# THE GLIDING FEDERATION OF AUSTRALIA

## AIRWORTHINESS DIRECTIVE GLIDERS/POWERED SAILPLANES

GFA/AD 235

SUBJECT: Tailplane, front fitting.

Front tailplane fitting

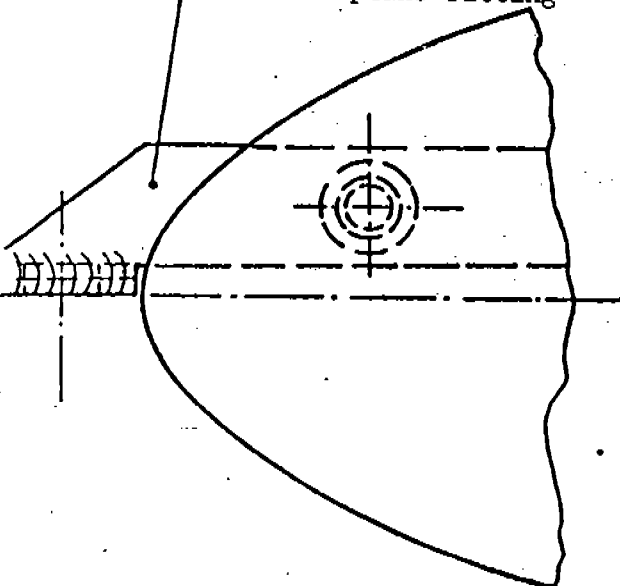
BACKGROUND: Possible manufacturing defects in the welded seams.

- (a) Dismount the tailplane from the fuselage.
- (b) Remove the paint from the front tailplane fitting (see sketch).
- (c) Inspect the fitting in the area of the welding seams for cracks by using a magnifying glass of at least 5 x power.
- (d) If cracks are found, then a new fitting must be mounted prior to the next flight. The defective fitting must be sent to the manufacturer (giving the total number of flight hours), with the request for a new fitting.
- (e) If no cracks are found, the fitting is to be protected against corrosion with prime and then painted.

IMPLEMENTATION: Inspection and replacement if required, to be carried out by a DOT 1109 holder endorsed C. of A. metal. A detailed log book entry to be made on completion.
